**Bulletin Number:** TB-240201

**Subject:** PH25AG-A and PH55AG-A One-Way Fuel Check Valve U65D-X419

**Issue Date:** Feb. 6, 2024 (Revised May 23, 2025)

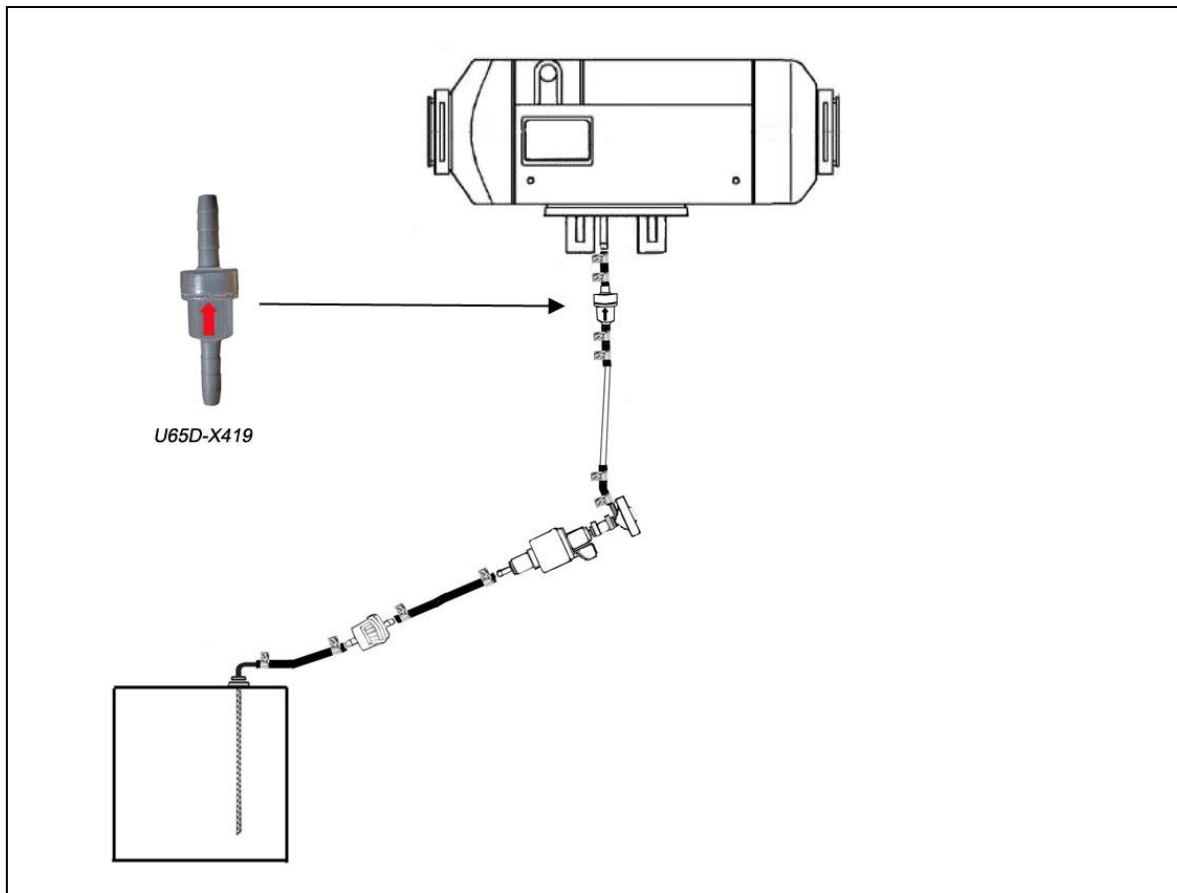
The original manual did not show the One-Way Check Valve required for the fuel system.

It is necessary to install this to ensure the fuel system will operate properly.

Failure to install this may cause starting problems and or inconsistent combustion.

Connect One-Way Check Valve U65D-X419 in fuel system between fuel pump and heater as shown.

Arrow on Check Valve should be pointed in direction of fuel flow (towards heater).
